ADDENDUM TO DOCK PLANS

COMMUNITY OF HARBOR BAY ISLE
LAGOON DOCK PLAN REVISIONS
ADOPTED BY THE COMMUNITY
ARCHITECTURAL COMMITTEE
JUNE 14, 1993

DOCK PLANS, -12/93

FRAMING PLAN

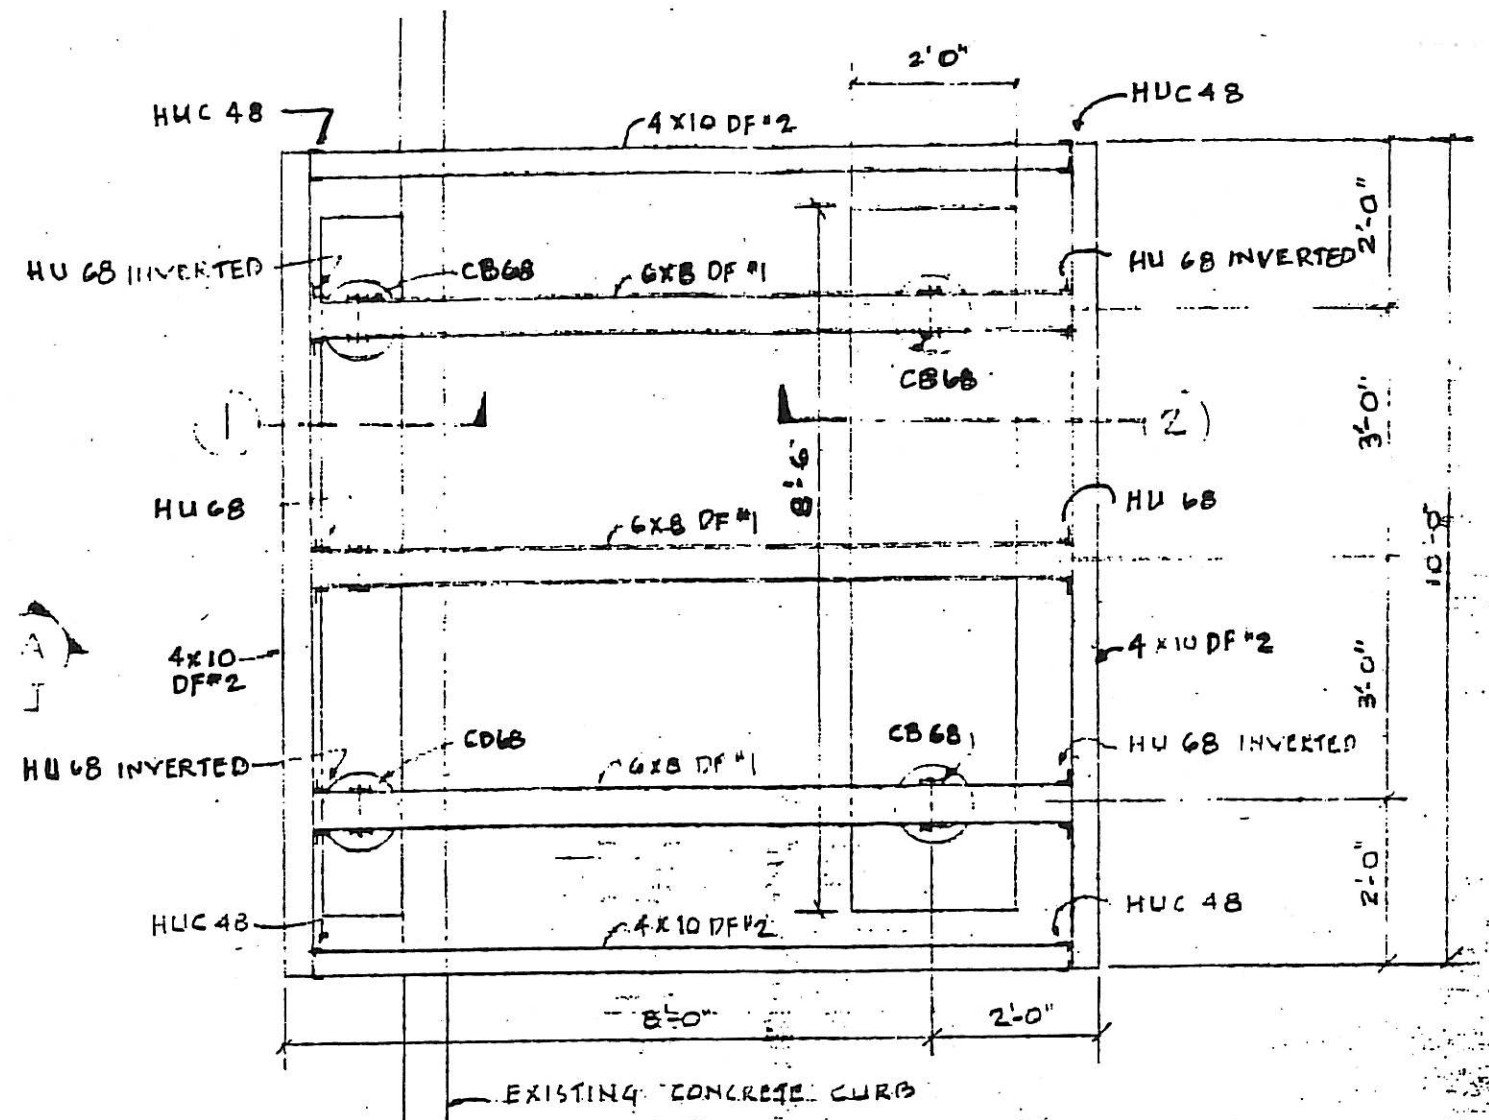
If the owner chooses the option of installing poured-in-place concrete piers instead of pre-cast piers, epoxy-coated rebar shall be installed in the concrete. The concrete shall be a mix formulated to withstand salt water intrusion.
